OWNER: Home Investments Inc PHONE: 449-5912 DATE REQUESTED: 11-9-93 DATE EVALUATED: 11-22-93  
 ADDRESS: RT 2 BOX 272-B CAMDEN PROPERTY IDENTIFICATION NO.: \_\_\_\_\_  
 COUNTY: HANNOCK PROPERTY SIZE: \_\_\_\_\_ PROPOSED FACILITY: 3 BED ROOM  
 LOCATION OF SITE: MIRE BRANCH 2 STATES LOC 114  
 WATER SUPPLY: On-Site Well \_\_\_\_\_ Community \_\_\_\_\_ Public X EVALUATION BY: Auger Boring (JW) PR \_\_\_\_\_ CUT \_\_\_\_\_

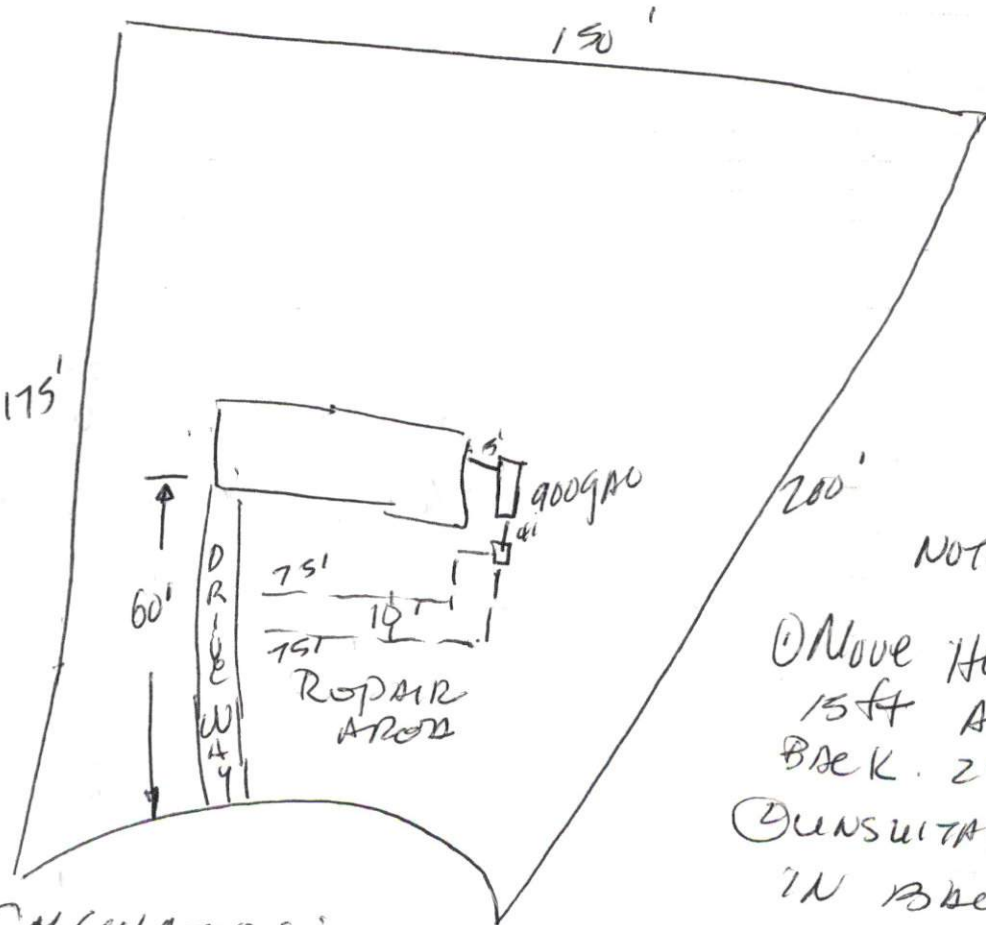
NOTE:  
 (1) Move HOUSE sideways 15ft AND TO THE BACK 25ft.  
 (2) UNSUITABLE SOIL IN BACK OF LOT.

CLASSIFICATION: *S41 TABLE (FROM)* SITE LONG-TERM ACCEPTANCE RATE: *.8*  
 RECOMMENDED BY: *John A. O'Connell* OTHER(S) PRESENT:  
 NOTES:  
 (1) RELOCATE HOUSE TO THE LEFT SIDE AND TO THE BACK (SEE DRAWING)  
 (2) RELOCATE DRIVEWAY SEE DRAWING
